#	DETAIL OF CHANGE(S)		REASON FOR CHANGES
1	Change of a Power Transformer in Power Supply Assy	1	To prevent flicker of picture

MODEL:SD-P5107

SERVICE INFORMATION

Date: Oct.13,2000 **No.:** SI-D01008 (1/2)
MODEL No. * **SER.No.** **S/M No.** **PG**

PDP-502 series
Replacement parts location of POWER SUPPLY ASS'Y
(Ref. A: AWZ6405, Ref. B: AWZ6506)

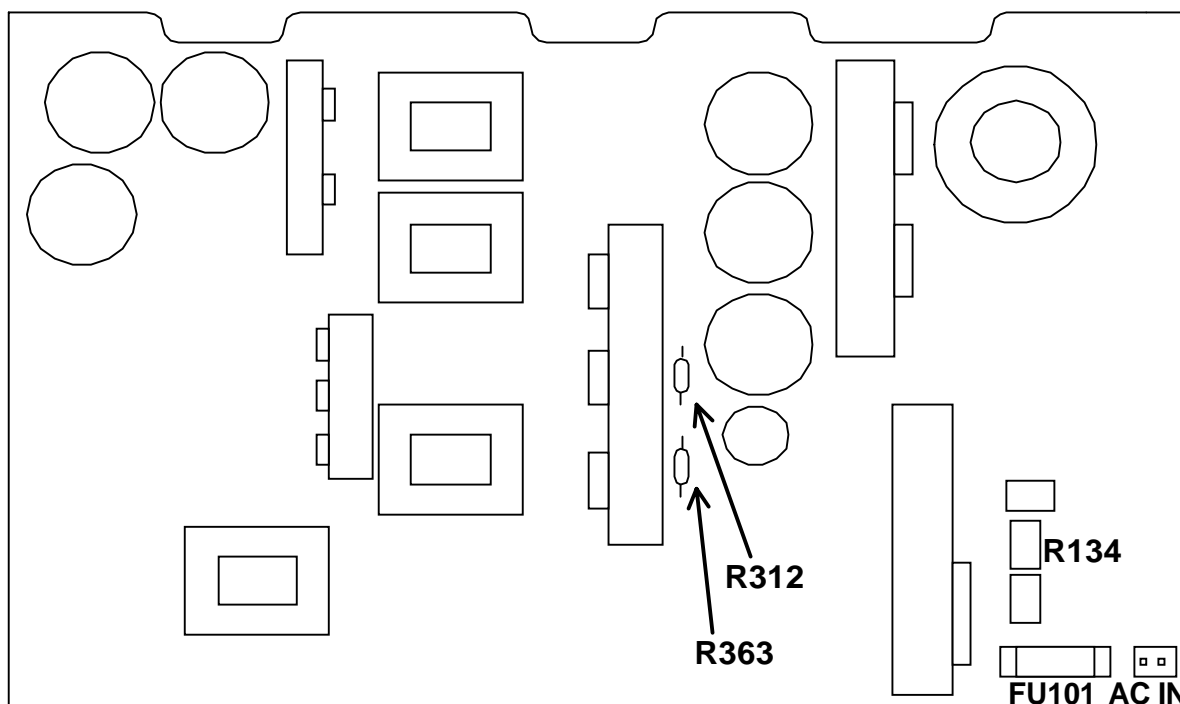
Service Remedy 2-c. [Change resistors / R363, R312 and R134]

R363, R312	Current part No : RS1LMFR22J
	New part No : ACN1157

Y DRIVE ASS'Y AWZ6683 (433 series) / AWZ6645 (503 series)

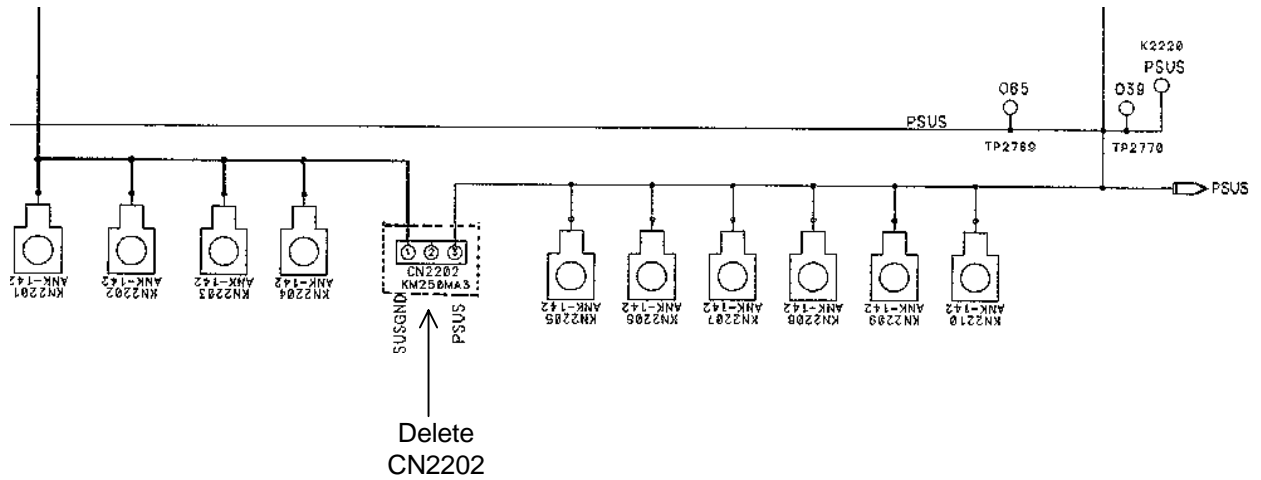
DETAIL # CHANGE
1 Created new X and Y Drive Assy

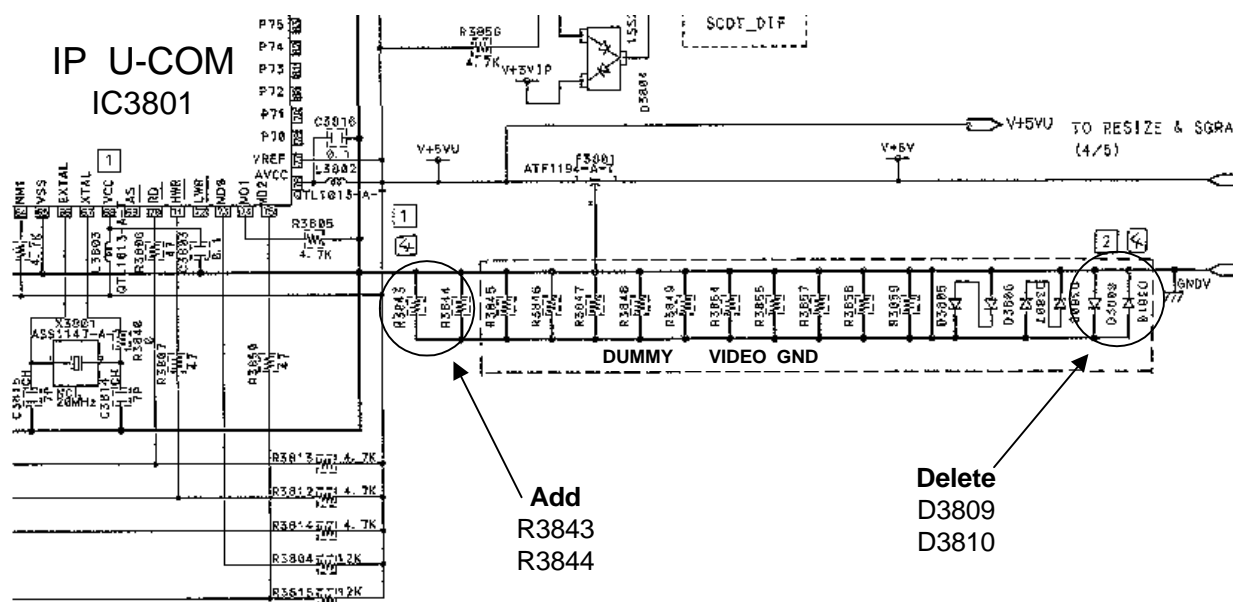
DETAIL 1 Change of parts in AWW1890 and AWW1910 of VIDEO IP A'SSY.

REASON 1 To prevent mis-operation when electricity is discharged.

Ref		CURRENT	PARTS	CO	NEW	PARTS
*	#	SYMBOL/DESCRIPTION	PART NUMBER	DE	PART NUMBER	SYMBOL/DESCRIPTION
A	1	D3809	1SS352-TRB		Deleted	
A	1	D3810	1SS352-TRB		Deleted	
A	1		Added		R3843	RS1/16SOROJ
A	1		Added		R3844	RS1/16SOROJ

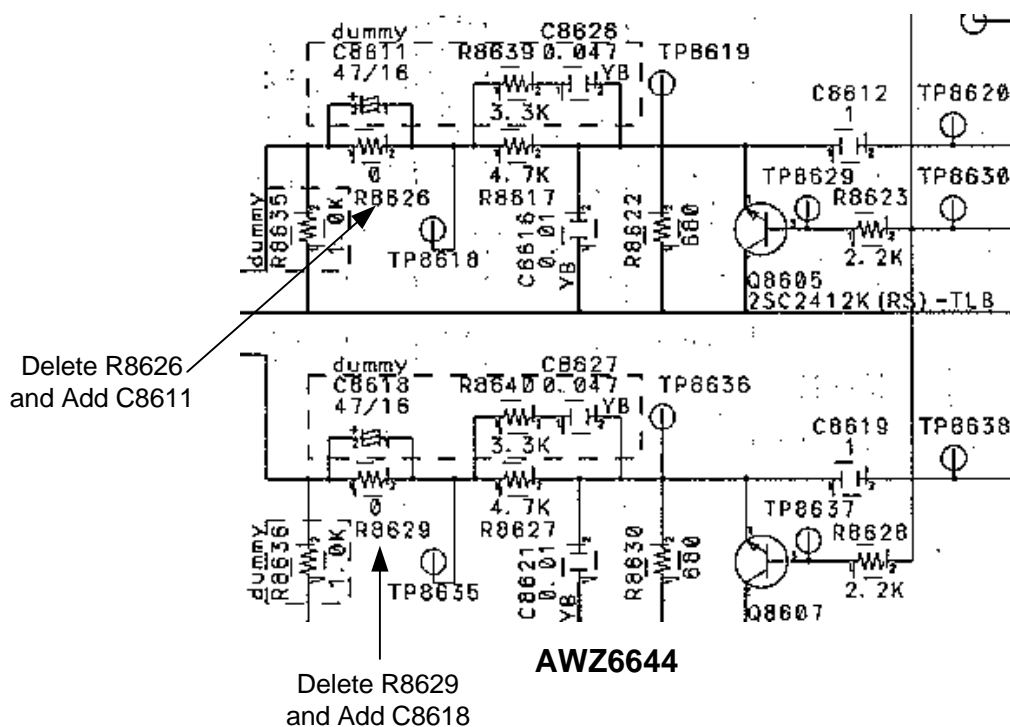
#	CHANGE
DETAIL	1	Change of parts in AWZ6644

REASON	1	Remedy for not emitting the pop sound when the input is switched or when the power supply is turned on and off.
--------	---	---

Ref		CURRENT	PARTS	CO	NEW	PARTS
*	#	SYMBOL/DESCRIPTION	PART NUMBER	DE	PART NUMBER	SYMBOL/DESCRIPTION
A	1		Added		CEAT4R7M50	C8611
A	1		Added		CEAT4R7M50	C8618
A	1	R8626	RS1/16S0R0J	Deleted		
A	1	R8629	RS1/16S0R0J	Deleted

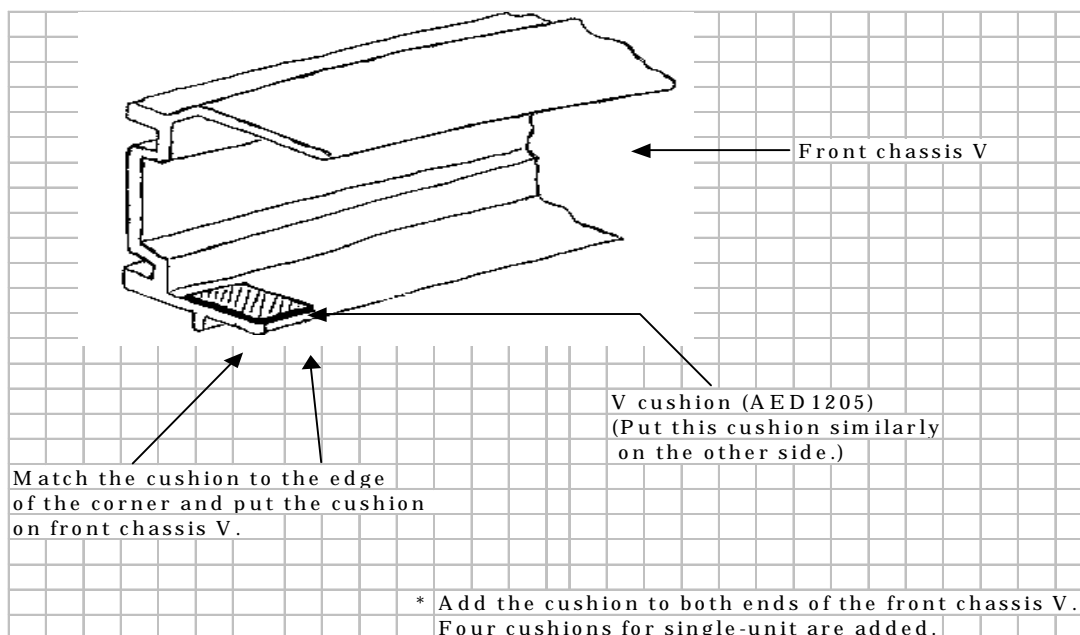
DETAIL # **CHANGE**
1 Add the V cushion to the panel side of front chassis V.

REASON 1 To prevent the interaction between panel and front chassis V.

Ref		CURRENT	PARTS	CO	NEW	PARTS
*	#	SYMBOL/DESCRIPTION	PART NUMBER	DE	PART NUMBER	SYMBOL/DESCRIPTION
A	1		Added	-	AED1205	3429

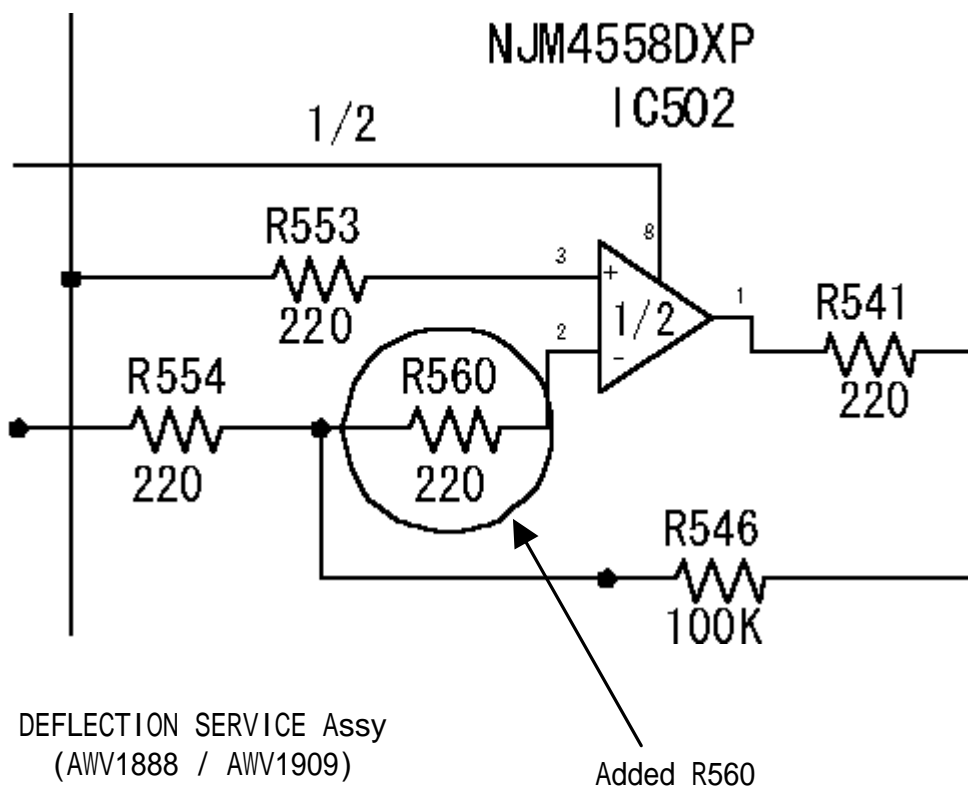
DETAIL # **CHANGE**
1 Addition of a resistor in DEFLECTION SERVICE Assy (AWV1888, AWV1909)

REASON 1 To prevent IC502 being destroyed when electricity is discharged.

Ref		CURRENT	PARTS	CO	NEW	PARTS
*	#	SYMBOL/DESCRIPTION	PART NUMBER	DE	PART NUMBER	SYMBOL/DESCRIPTION
A	1		Added	-	RD1/4PU221J	R560

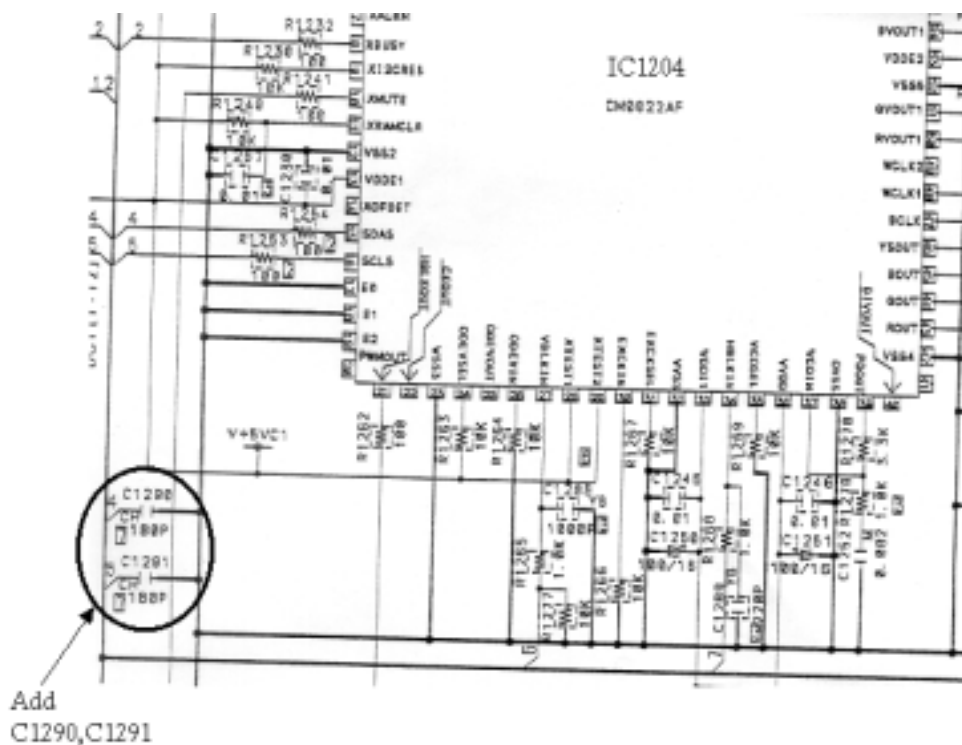
#	CHANGE
DETAIL	1	Addition of capacitors in DIGITAL CONV. Assy (AWV1892)

REASON 1 Countermeasure for broken convergence data problem.

Ref		CURRENT	PARTS	CO	NEW	PARTS
*	#	SYMBOL/DESCRIPTION	PART NUMBER	DE	PART NUMBER	SYMBOL/DESCRIPTION
A	1		Added	-	CCCCH181J50	C1290
A	1		Added	-	CCCCH181J50	C1291

Y DRIVE Assy

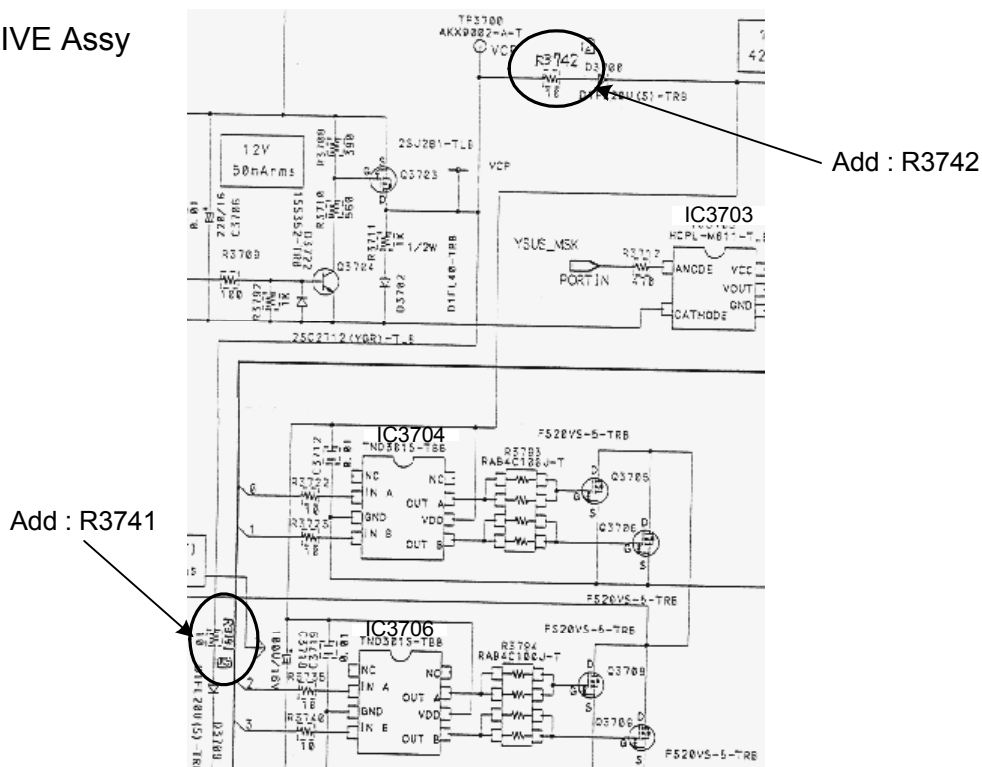
REASON 1 To prevent open CP line resistor.
